# *Californians For High Speed Rail*

December 4, 2009

## **RE: Altamont Corridor Scoping Comments**

**Figure 1. Proposed New Alternative #1 - Junction of Three Branch System to San Francisco, Oakland, and San Jose (via Niles Canyon, Route 84, Dumbarton, and UPRR/Former SP ROW)**

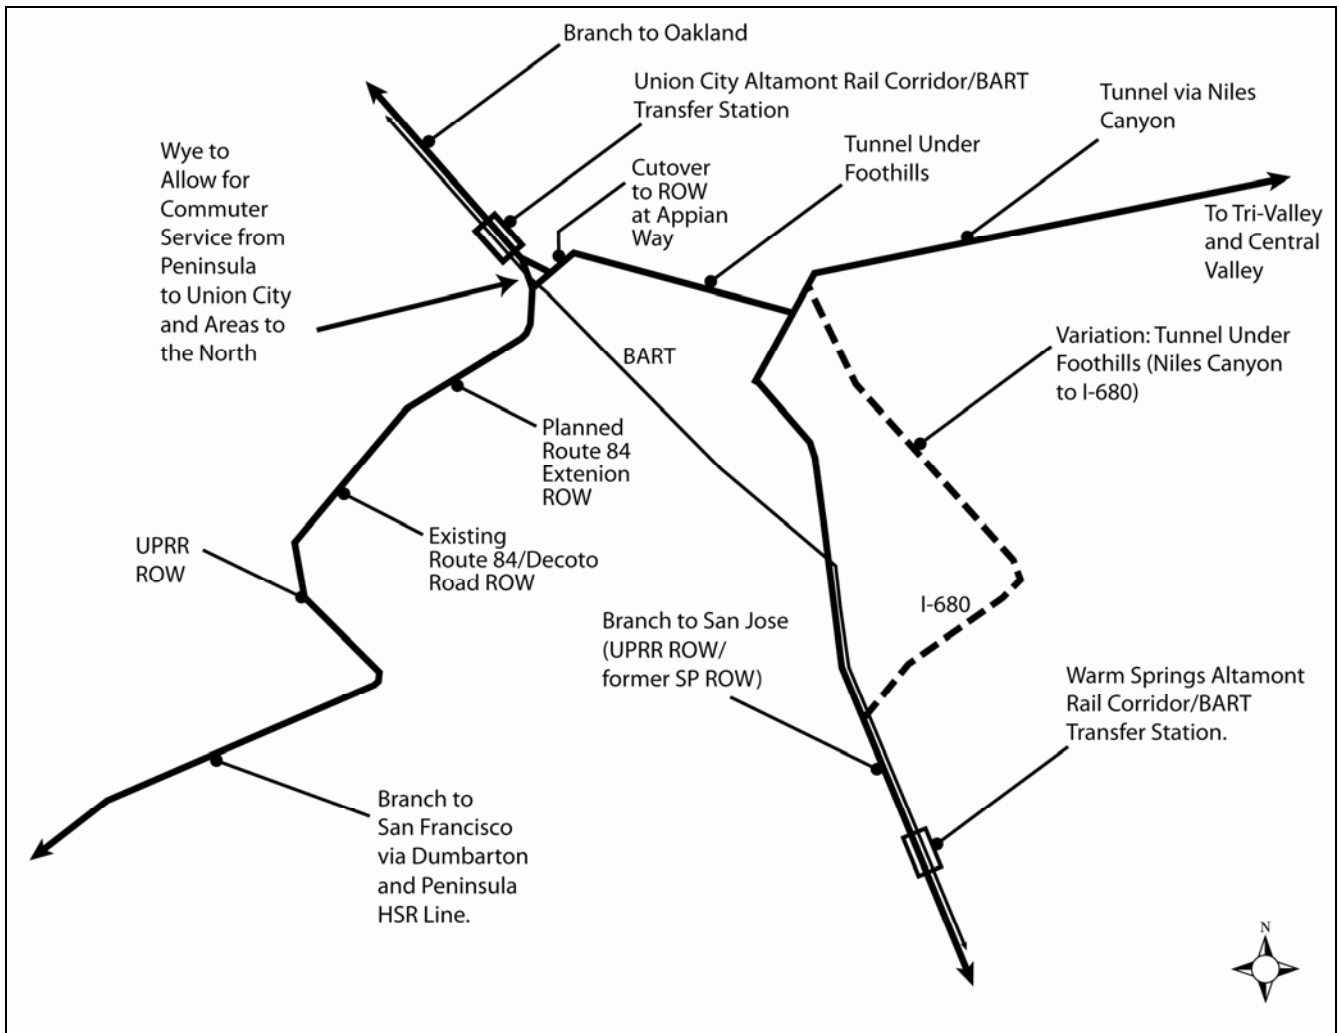
- **Proposed New Alternative #1: Junction of Three Branch System to San Francisco, Oakland, and San Jose (via Niles Canyon to Union City, Route 84/Decoto, Dumbarton, and BART Alignment)**

This alignment would follow the Niles Canyon route described in the CHSR 2008 EIR/EIS. After exiting the canyon, trains would eventually split into three separate branches, with one branch headed to San Francisco, the second to Oakland, and a third to San Jose (see Figure 1). The San Francisco branch would exit the Niles Canyon and then turn northwest along the foothills and travel at grade (cut/fill) or through a tunnel. It would then turn west at Appian Way and travel along the Route 84 extension ROW as well as the exiting Route 84/Decoto ROW. Then the San Francisco branch would turn south along the UPRR Alviso line, or Thornton Avenue, to the Caltrain-owned railroad ROW where it would turn west to cross the Dumbarton rail bridge to access the planned HSR ROW along the Peninsula, where it would travel to San Francisco.

The San Jose branch would head south and utilize the former Southern Pacific ROW south from Niles Canyon with a stop at Warm Springs before heading south to Santa Clara County. A variation on this would have trains branch to the south farther east and tunnel under the foothills until reaching I-680, where it would then follow I-680 and then cut over to the ex-SP ROW. (see dashed line in Figure 1).

**Figure 2. Proposed New Alternative #2 - Junction of Three Branch System to San Francisco, Oakland, and San Jose (via Niles Canyon, UPRR Centerville ROW, Dumbarton, and UPRR/Former SP ROW)**

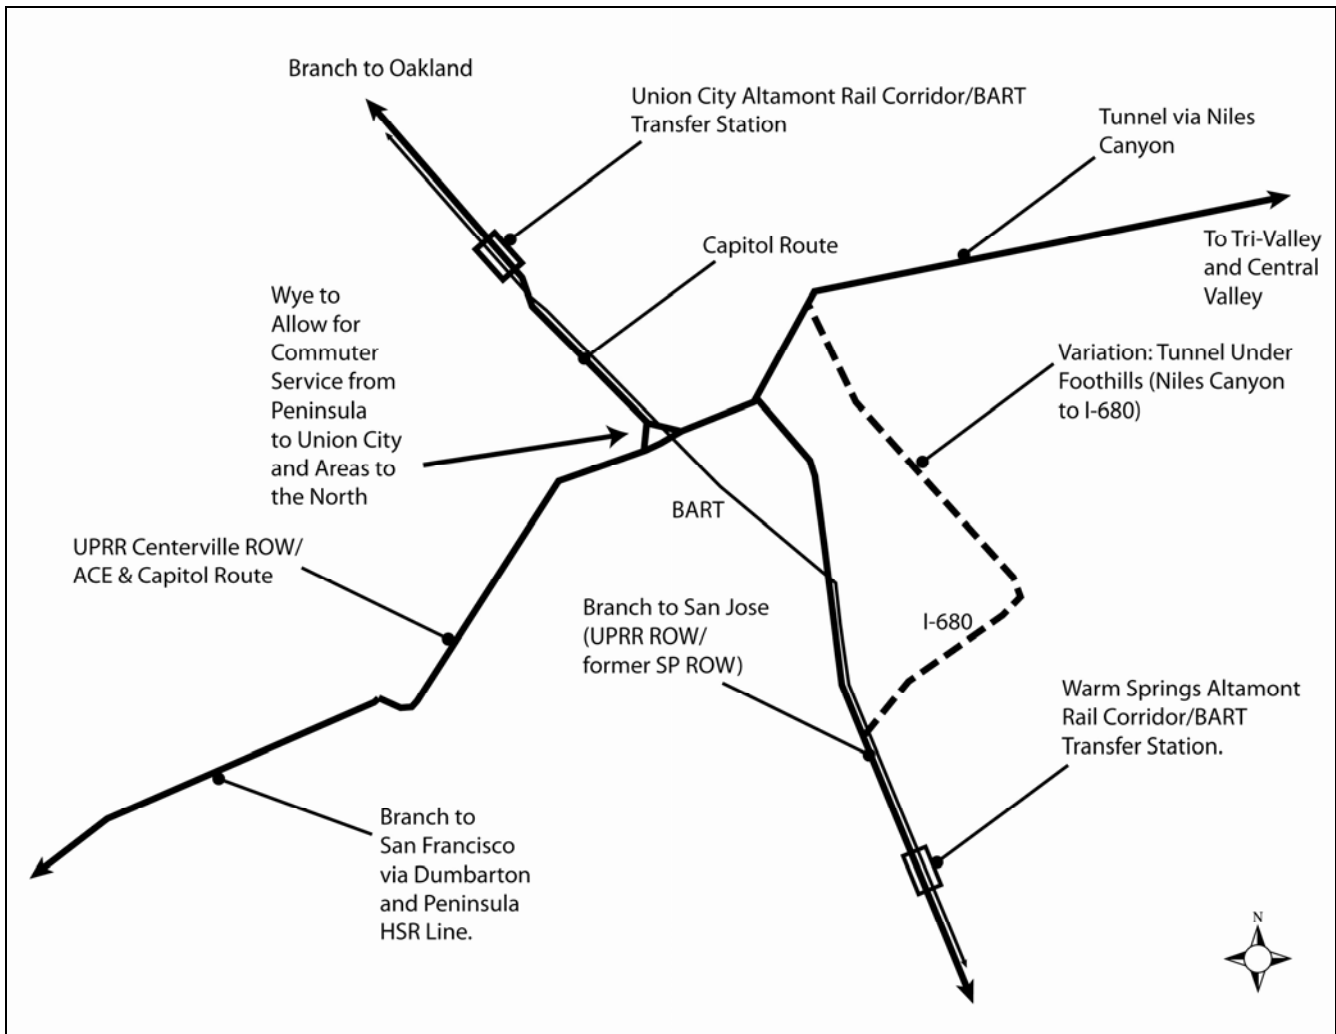
- Proposed New Alternative #2 - Niles Canyon to Newark via Centerville (ACE Alignment)**  
 This proposed alternative is very similar to the proposed new alternative #1 in that it would provide the same three branched service to San Francisco, Oakland (via the East Bay) and San Jose. The San Francisco branch would use an aerial or trench along the UPRR Centerville ROW (currently used by ACE/Capitol rail services) to Newark and the Dumbarton rail bridge. The Oakland branch would turn northward from the Centerville ROW along the Capitol Corridor route to Union City, and the north to Oakland. The San Jose branch would see no change from alternative #1. This alternative would also allow for ARCP to service the existing ACE/Capitol station in Centerville, whereas proposed alternative #1 would bypass this station.

**Figure 3. Proposed New Alternative #3 - Junction of Three Branch System to San Francisco, Oakland, and San Jose (via I-680, Auto Mall Parkway, Alviso Line, Dumbarton, and UPRR/Formal SP ROW)**

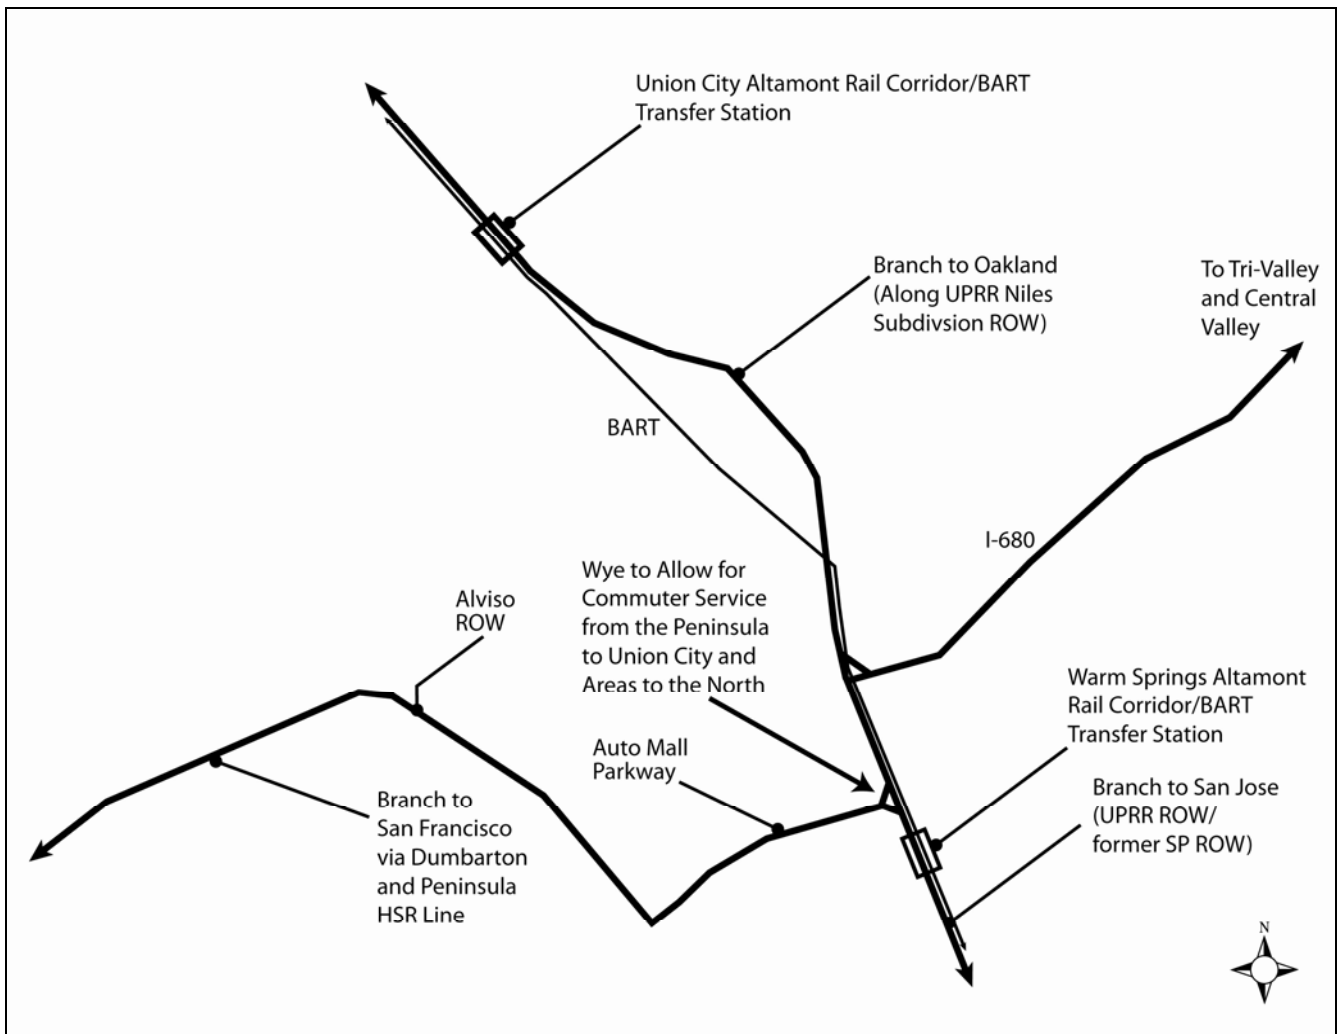
- Proposed New Alternative #3 - 680 to Warm Springs BART and Newark via Auto Mall Parkway/utility corridor**

The proposed new alternative #3 would approach the Fremont area from Livermore Valley via an I-680 alignment rather than Niles Canyon (as is the case in proposed new alternatives #1 and #2). The ARC service would then split into an Oakland branch and a San Jose branch around Blacow Road. The Oakland branch would follow the UPRR Niles Subdivision as defined in the 2008 EIR/EIS north through Union City, and then on to Oakland. The San Jose branch would follow the former Southern Pacific ROW southward, with the San Francisco branch splitting off west along Auto Mall Parkway, or the utility corridor approximately 1,000 feet north of the parkway. Then the San Francisco branch would turn north along the Alviso line until the Newark Junction where it turns west to continue to Dumbarton Bridge.

**Figure 4. Proposed Alternative #4 - Junction of Two Branch System to San Francisco and San Jose (via Niles Canyon, Route 84, Dumbarton, and UPRR/Formal SP ROW)**

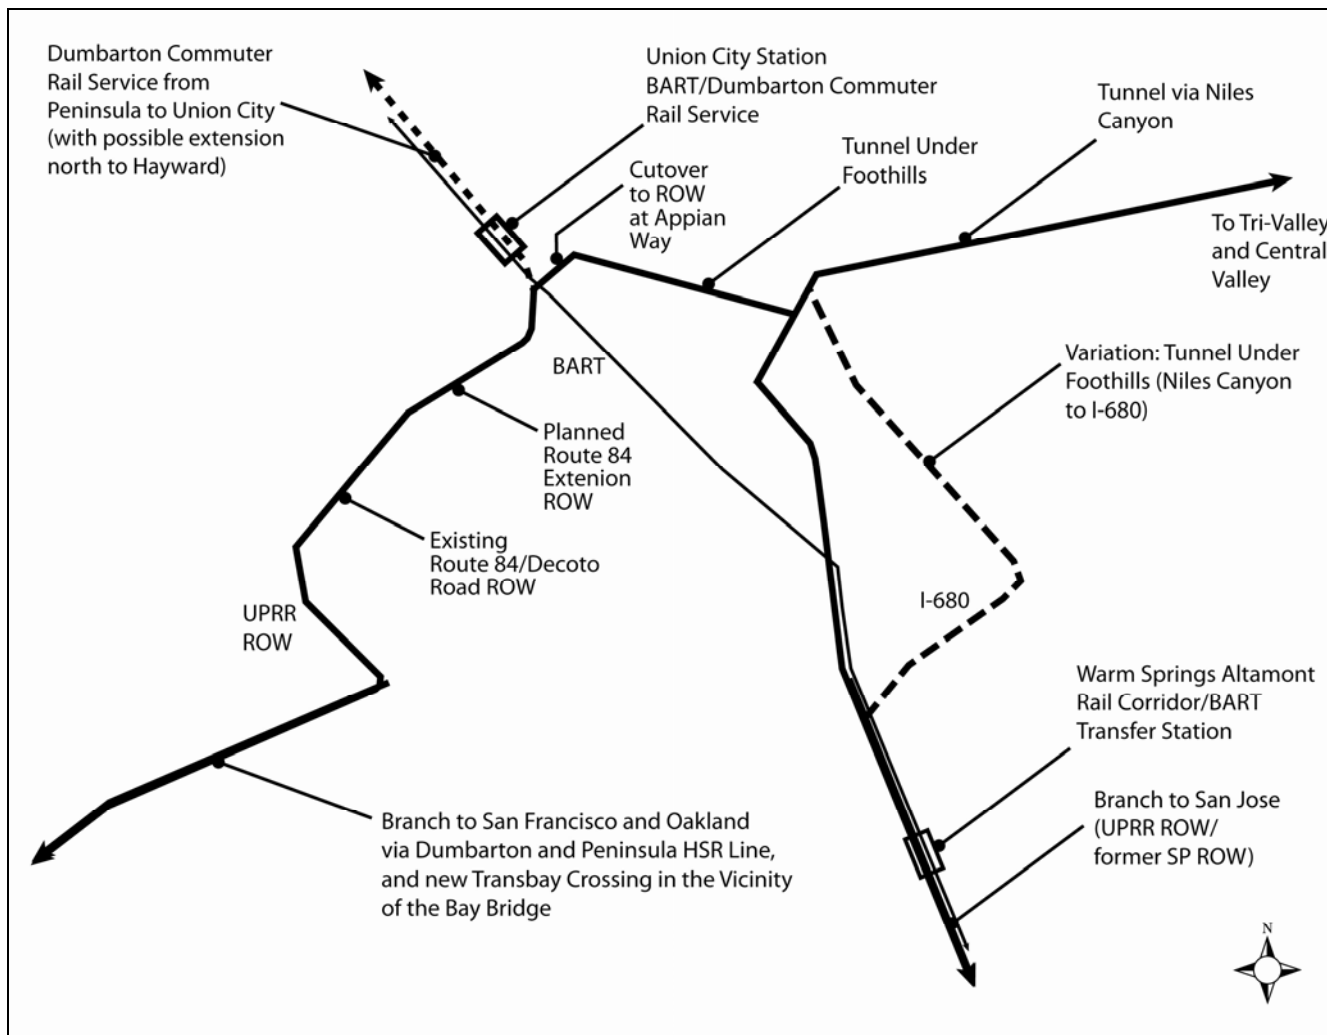
- **New Alternative #4 - Niles Canyon to Union City and Newark via Route 84/Decoto**

This alignment is similar to proposed new alternative #1 except Oakland is reached via a new Transbay Tube in the vicinity of the Bay Bridge rather than a line up the East Bay. The wye for the Union City intermodal station would be retained for Dumbarton commuter rail service only, with a possible extension to Hayward along the Oakland subdivision.

**Figure 5. Proposed Alternative #5 - Junction of Two Branch System to San Francisco and San Jose (via I-680, Auto Mall Parkway, Alviso, Dumbarton, and UPRR/Formal SP ROW)**

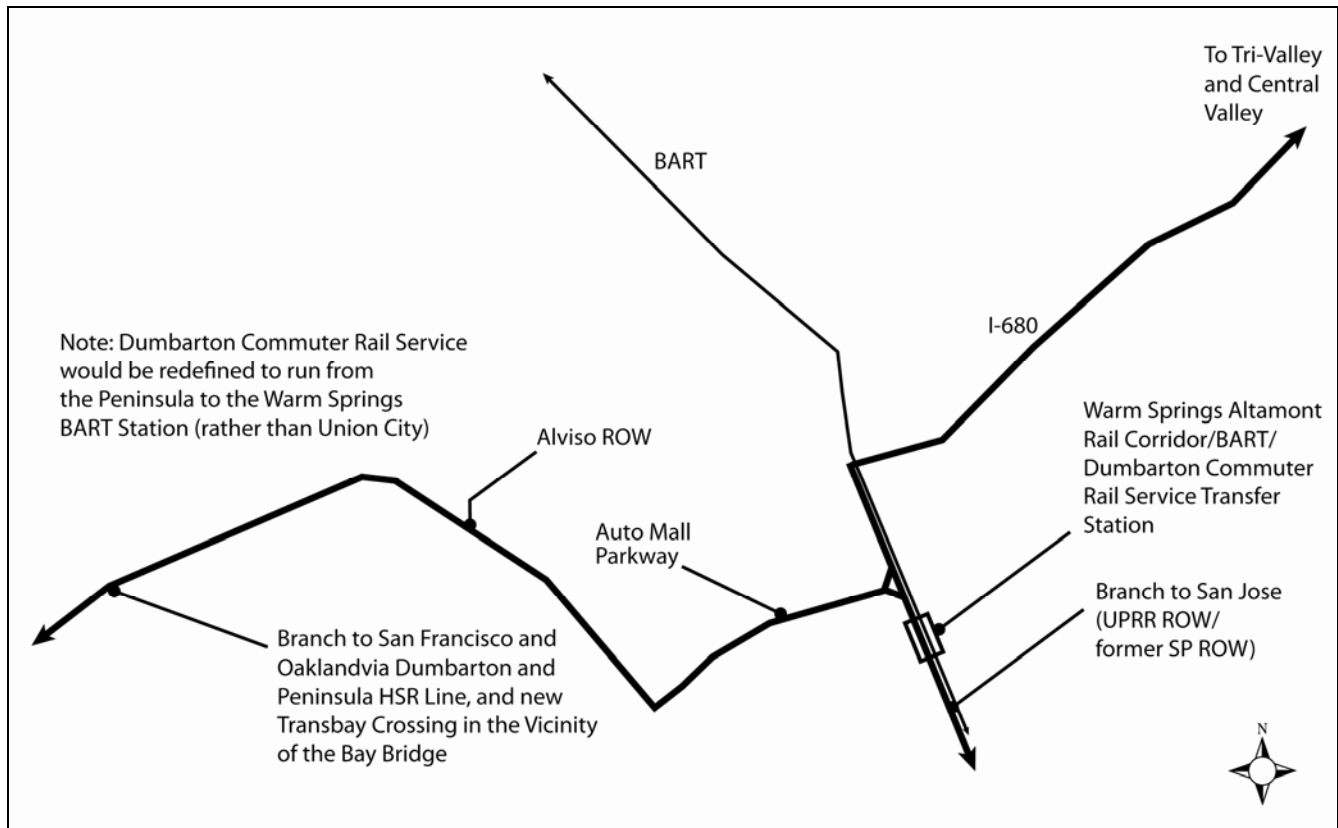
- **New Alternative #5 - to Warm Springs BART and to Newark via Auto Mall Parkway/utility corridor**

This alignment is similar to proposed new alternative #3 except Oakland is reached via a new Transbay Tube in the vicinity of the Bay Bridge rather than a line up the East Bay. The northern branch from alternative #3 is completely eliminated.

**Figure 6. Image of proposed Mineta Airport Station. (Image created by David Vasquez)**

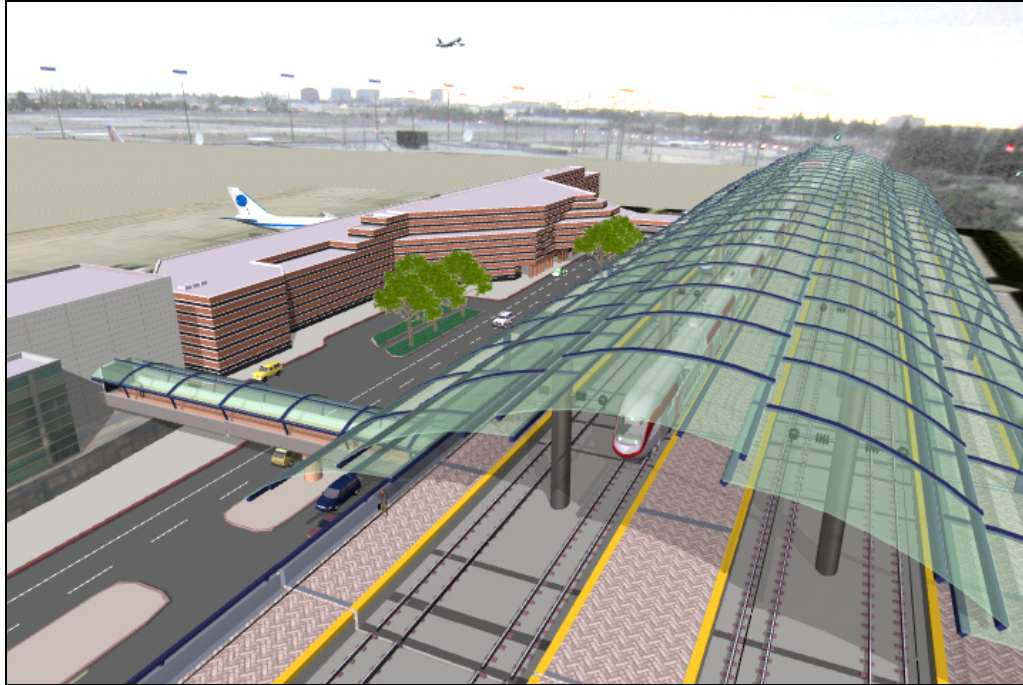
We would also like to **encourage the Authority and the Partnership to study the possibility of providing direct service to a station located immediately east of the terminals at the Mineta International Airport**, as envisioned by the Caltrain Metro East vision promoted by several organizations. This would be much more convenient than forcing riders to transfer to a people mover from a station in Santa Clara. This link would allow for the flexibility of some core HSR trains to head directly to the airport from Diridon station as well, or at least the ARC service could serve as a feeder to/from the airport for core HSR system riders (as current plans have no way for HSR riders to access the airport from/to Diridon Station unless they transfer to Caltrain and then to the proposed people mover).
